# Access Compliance Report

## Public Rights-of-Way

Intersection ID: 44958	Main Street: N_TRYON_ST	Cross Street: OLD_CONCORD_RD	Location: SE
ADA ID: 73A1FEF6856B	Ramp Type: MedianPerp	Initial Pass/Fail: Fail	Overall Compliance: No
Severity Score: 12.5			
Codes/Mitigation Info/Possible Solution		Field Measurements/Component Compliance

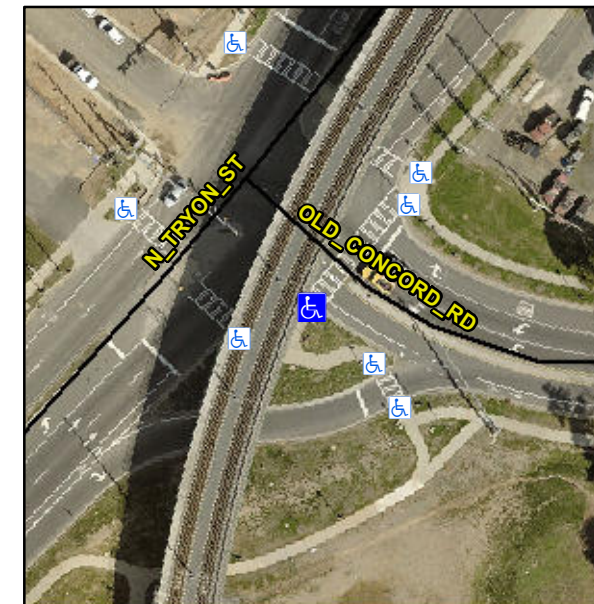
**Not Found, R304.2.2**

Compliance	Description	Data	Compliance	Description	Data
N/A	Ramp Length (in)	83.0	No	Ramp Slope (%)	8.7
Yes	Ramp Width (in)	96.0	Yes	Ramp XSlope (%)	0.0
N/A	Flare Type LT	N/A	N/A	Flare Type RT	N/A
N/A	Flare Slope LT (%)	N/A	N/A	Flare Slope RT (%)	N/A
N/A	Flare Traversable LT?	N/A	N/A	Flare Traversable RT?	N/A
N/A	Landing Length (in)	N/A	N/A	DWS Provided?	N/A
N/A	Landing Width (in)	N/A	N/A	DWS Contrast?	N/A
N/A	Landing Slope (%)	N/A	N/A	DWS Length (in)	N/A
N/A	Landing X Slope (%)	N/A	N/A	DWS Full Width?	N/A
N/A	Landing Curb? (Y/N)	N/A	N/A	DWS Offset (in)	N/A
N/A	Shared Landing?	N/A			
N/A	Gutter Ponding?	N/A	N/A	Gutter Slope (%)	N/A
N/A	Gutter Lip Ht (in)	N/A	N/A	Gutter X Slope (%)	N/A
N/A	Painted X Walk1?	Yes	N/A	Painted X Walk2?	N/A
	X Walk 1 Direction	To NE		X Walk 2 Direction	N/A
N/A	X Walk 1 Width (in)	118.0	N/A	X Walk 2 Width (in)	N/A
	X Walk 1 Slope (%)	2.0		X Walk 2 Slope (%)	N/A
	X Walk 1 X Slope (%)	1.5		X Walk 2 X Slope (%)	N/A

**Remove & Replace Entire Ramp.**
